MFN 06-429 Supplement 1

Subject: Supplemental Response to Portion of NRC Request for Additional Information Letter No. 59 Related to ESBWR Design Certification Application ESBWR - RAI Numbers 19.5-3 through 19.5-14

ESBWR Probabilistic Risk Assessment

Figure 19.5-13 (1) Comparison of Design Ground Spectrum with Soil and Rock Spectra

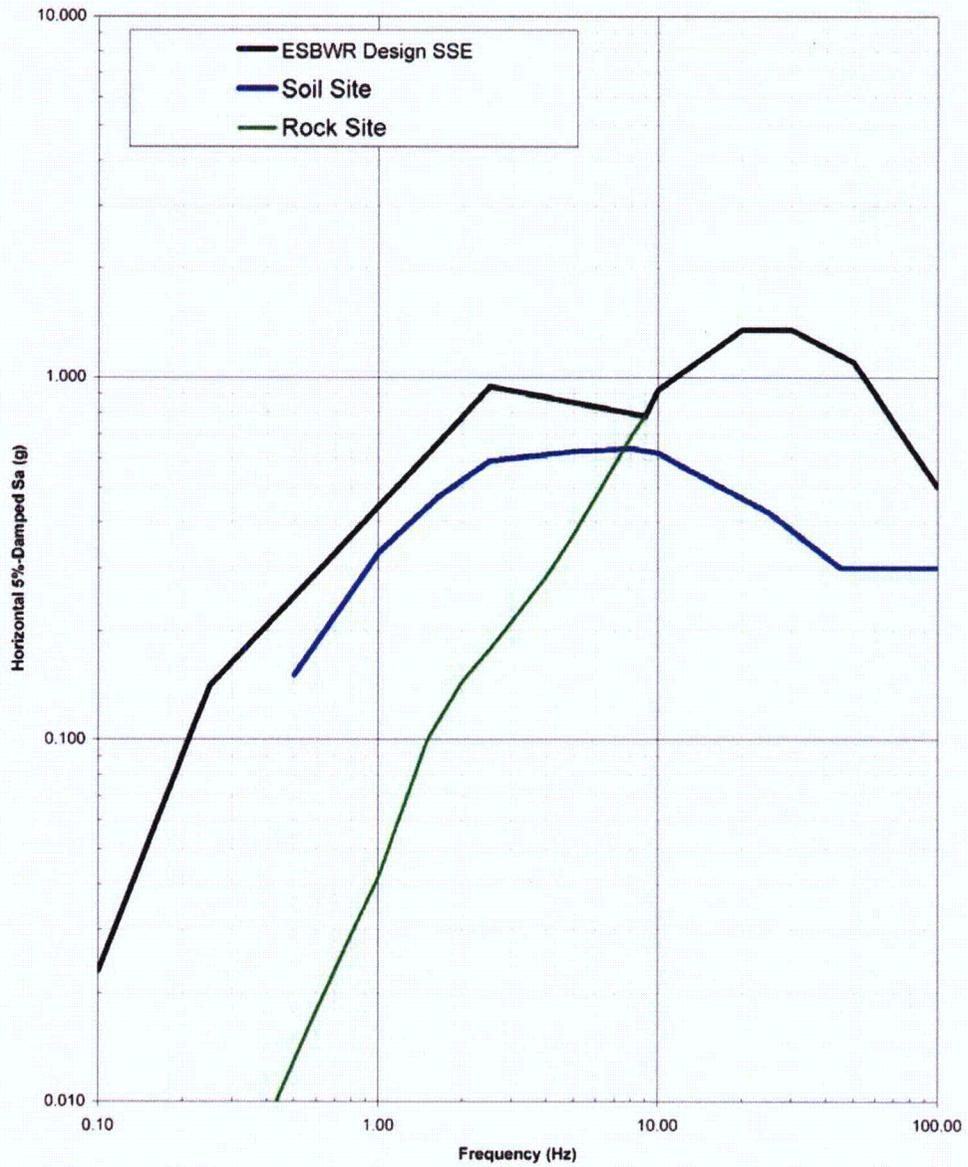
For the shape factor (Fsa), Section 15.3.3.1.2 of NEDO-33201, Rev. 1, states that for the purpose of seismic risk assessment, the median ground motion spectrum given in NUREG/CR-0098, "Development of Criteria for Seismic Review of Selected Nuclear Power Plants," is considered to be the realistic input ground motion definition. Considering the significant number of advancements in the field of seismic hazards since the development of this spectrum in the late 1970's, justify your consideration of the NUREG/CR-0098 spectrum as realistic input ground motion.

The spectral shape factors are reevaluated for two site conditions: rock and soil. For rock sites, the North Anna ESP site SSE spectrum is compared to the ESBWR single envelope design spectrum to determine the shape factor. For soil sites, the bounding SSE spectrum of soil sites among the 28 sites (excluding Vogtle) included in the current EPRI study (Reference 19.5-13(1)) is compared to the ESBWR single envelope design spectrum to determine the shape factor. Figure 19.5-13(1) shows this spectra comparison.
